ADDENDUM NUMBER THREE
TO THE CONTRACT DOCUMENTS FOR CONSTRUCTION OF
ORANGE BEACH RECREATION COMPLEX
NEW BASEBALL/SOFTBALL FIELD RENOVATIONS AT ORANGE BEACH SPORTSPLEX
CITY OF ORANGE BEACH

This addendum forms a part of the Contract Documents and modifies the Bid Documents dated May 4, 2020.

This Addendum consists of three (3) page Addendum, one (1) general documents, one (1) Specification & thirteen (13) full-size sheets.

DRAWING NO.
C301

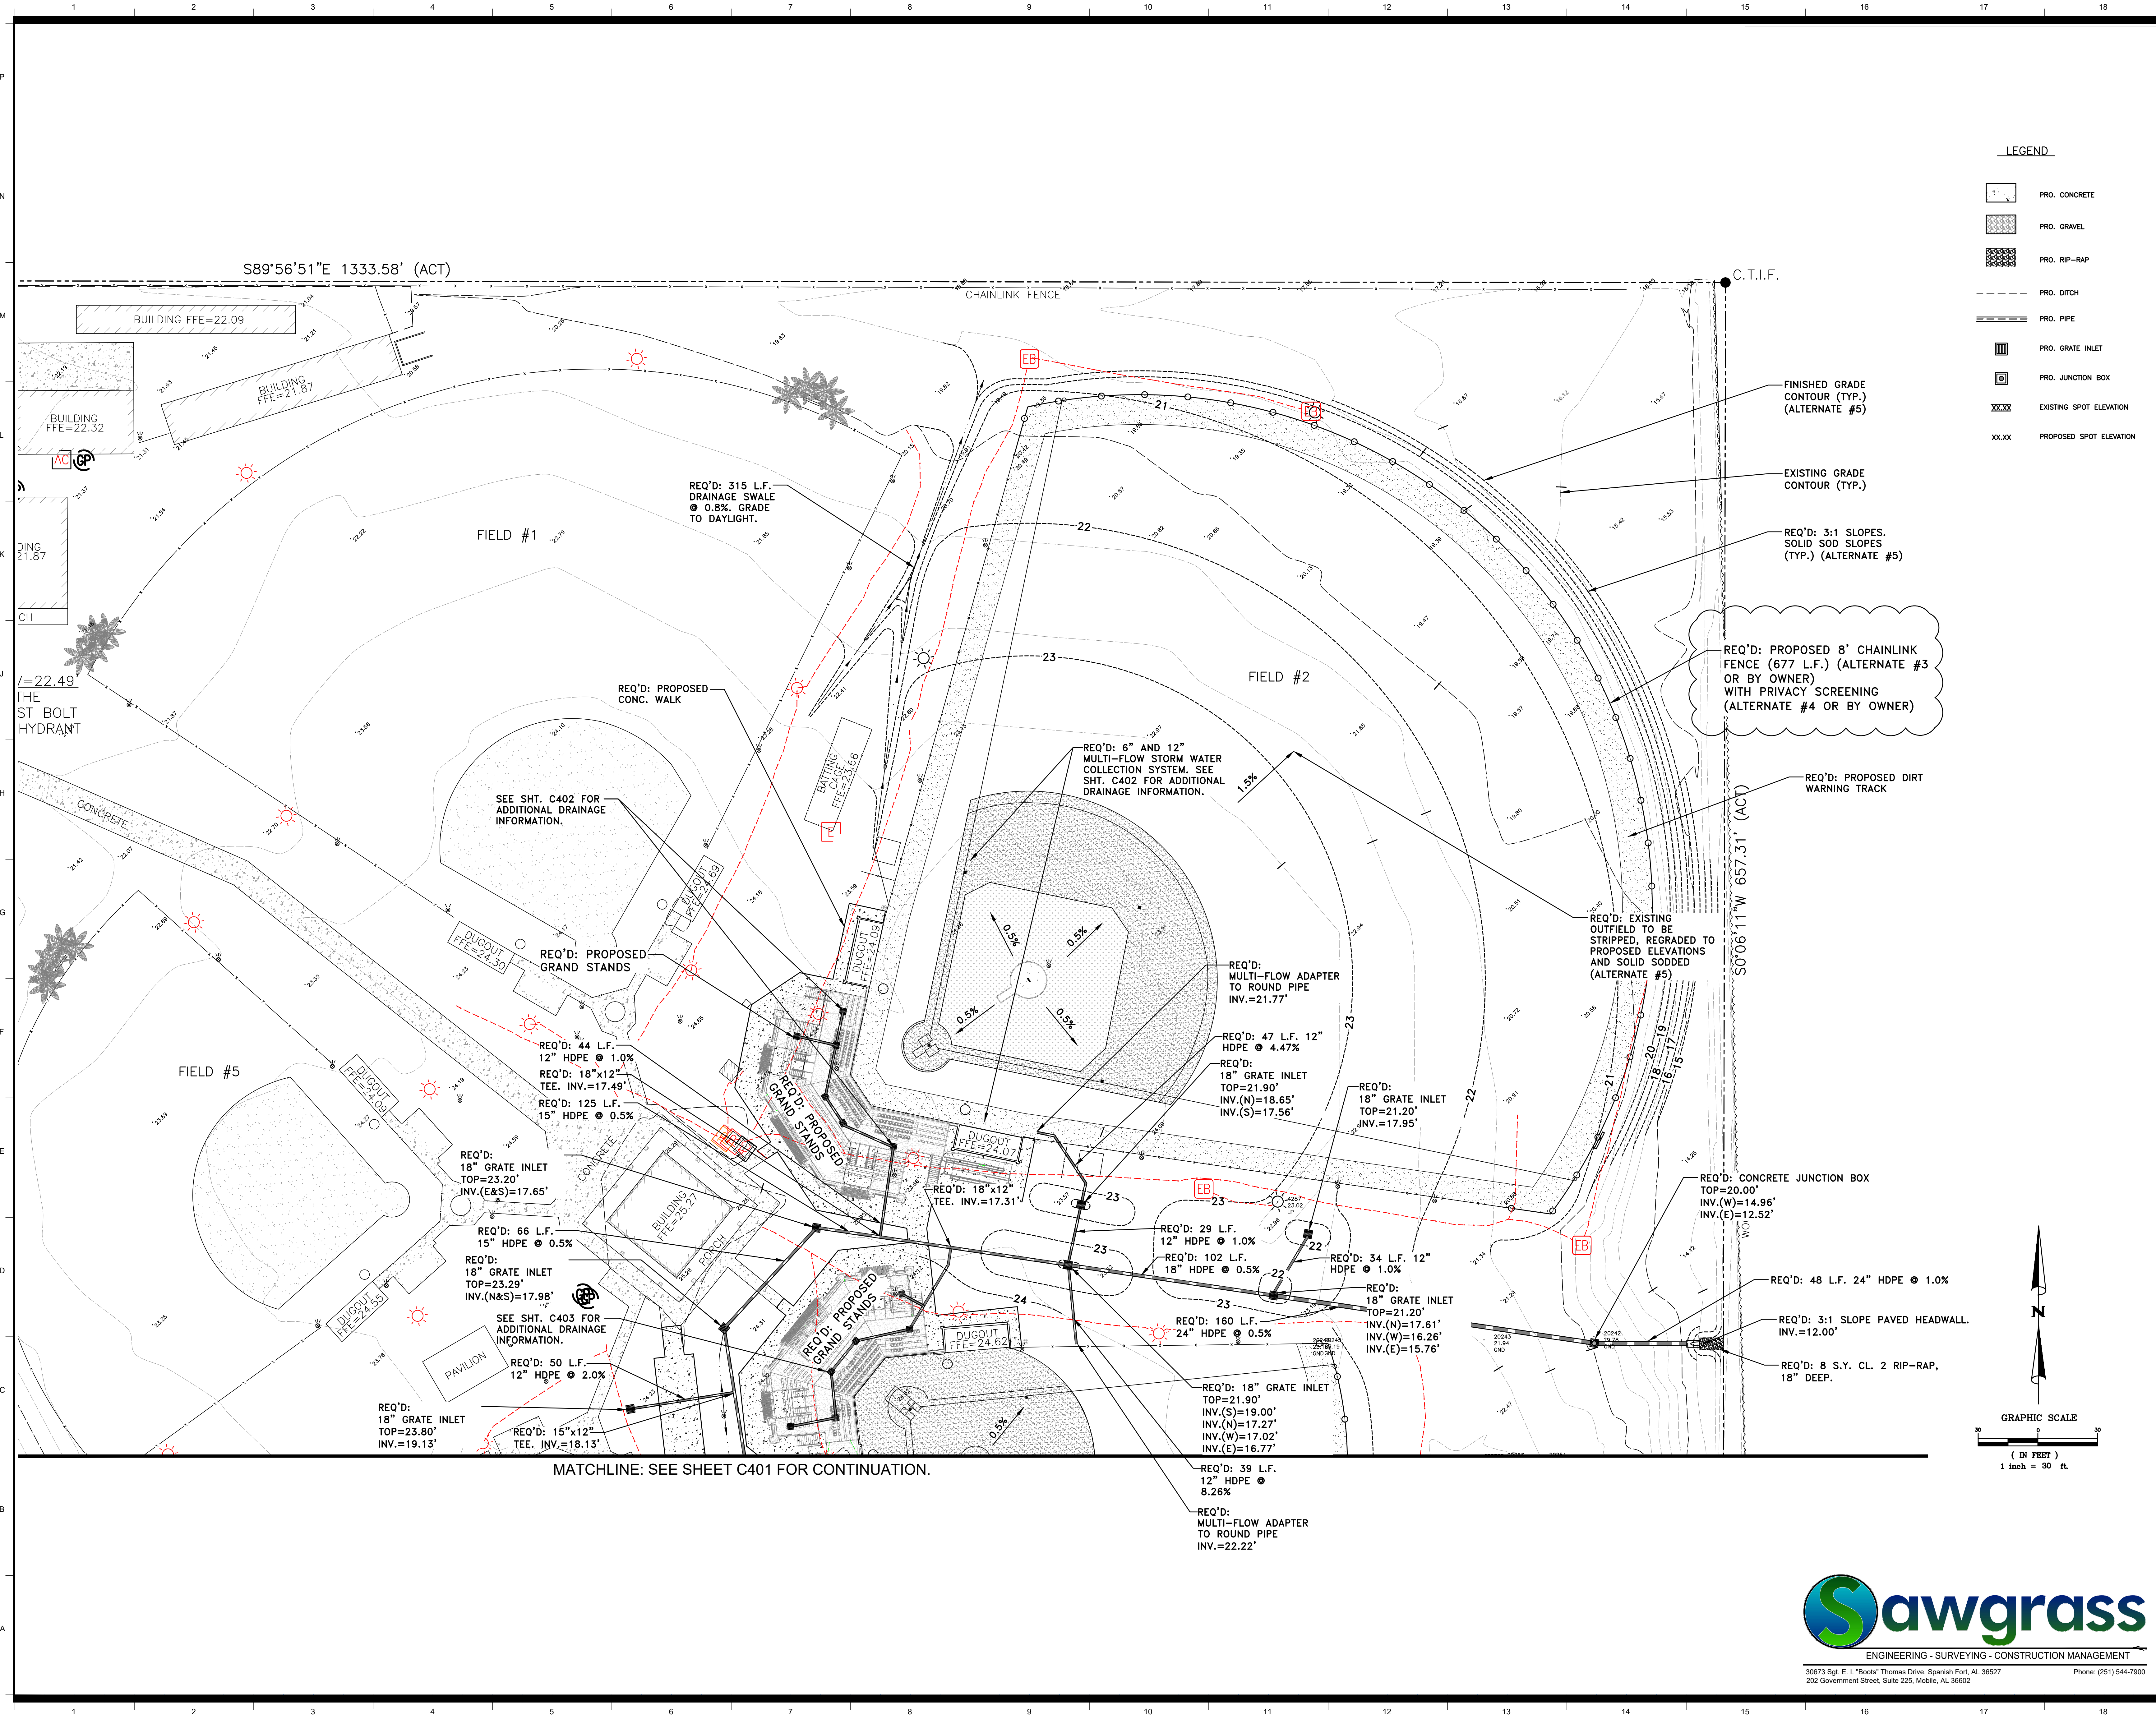
ITEM 03 SHEET C301 – GEOMETRY PLAN #2

3. Revised the notes of the Outfield fencing of Field 3 to Clarify scope and alternates.
4. Add Notes
 - a. Directing the GC to connect the new outfield fence to the existing field fence.
 - b. Adding note showing additional areas where fence screening is required for Alternate #4.
 - c. Providing signage for fire lane and painting the ground with striping.

C401

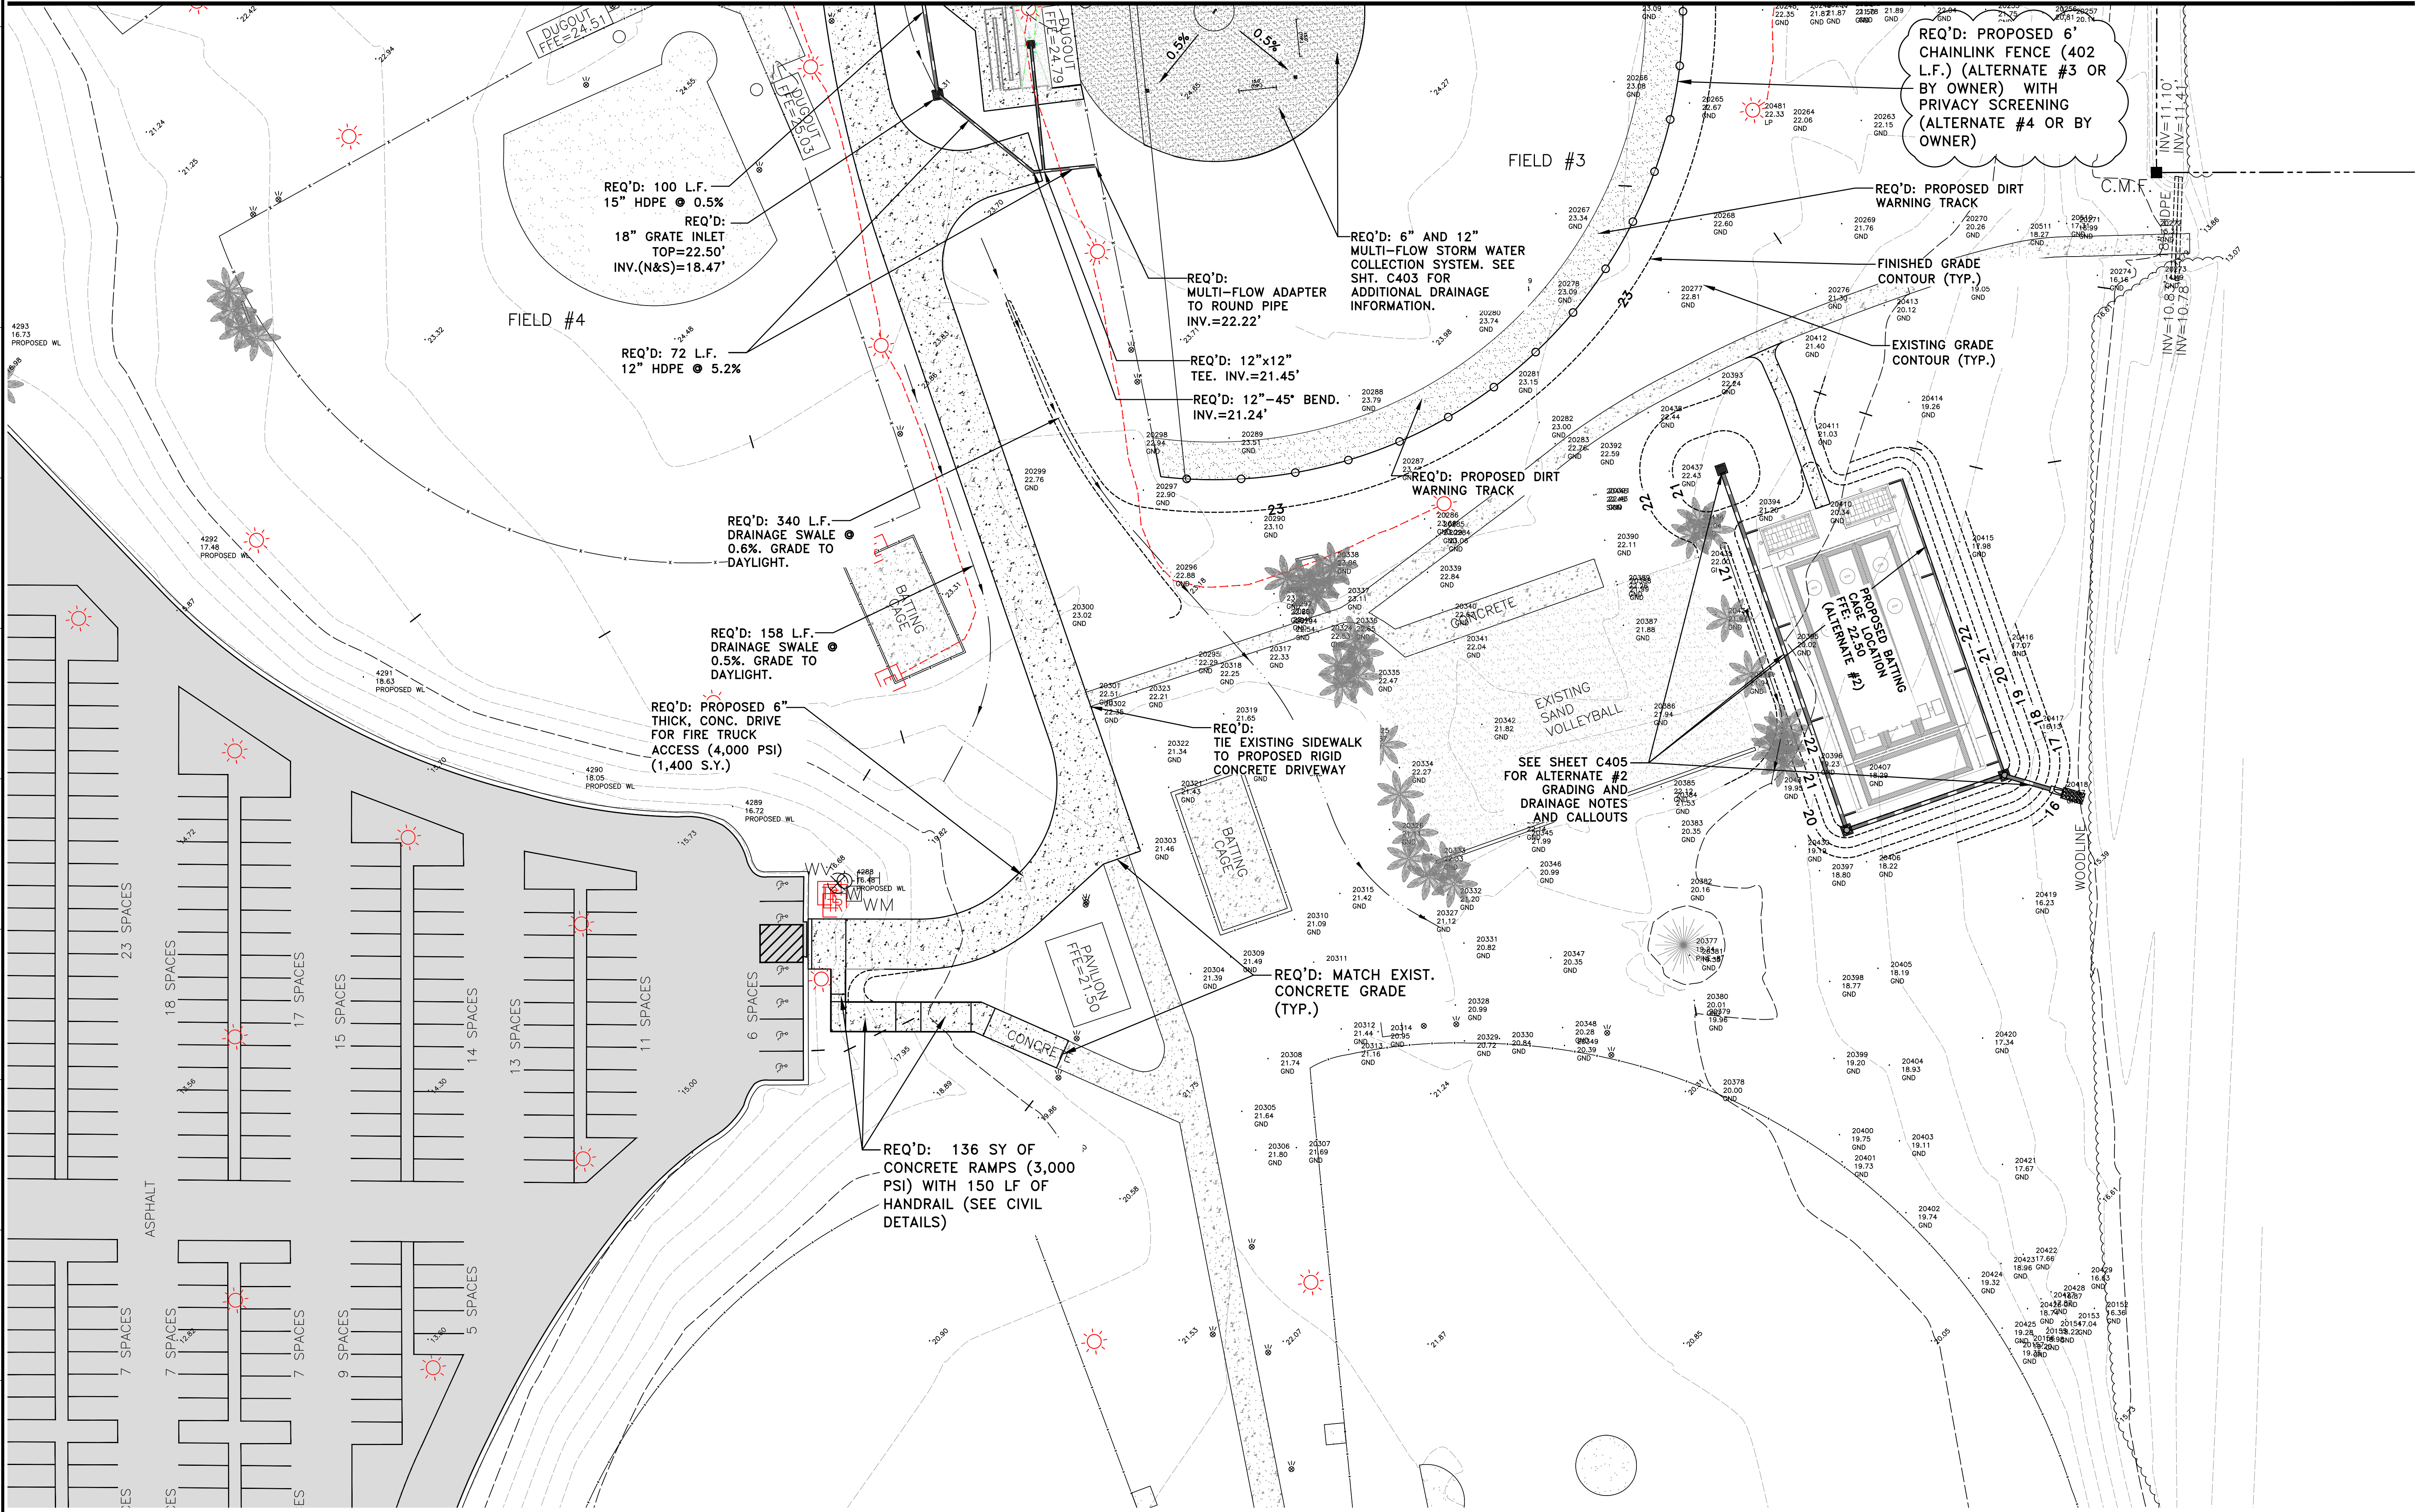
ITEM 05 SHEET C401 – GRADING OVERVIEW #2

1. Revised the notes of the Outfield fencing of Field 3 to Clarify scope and alternates.
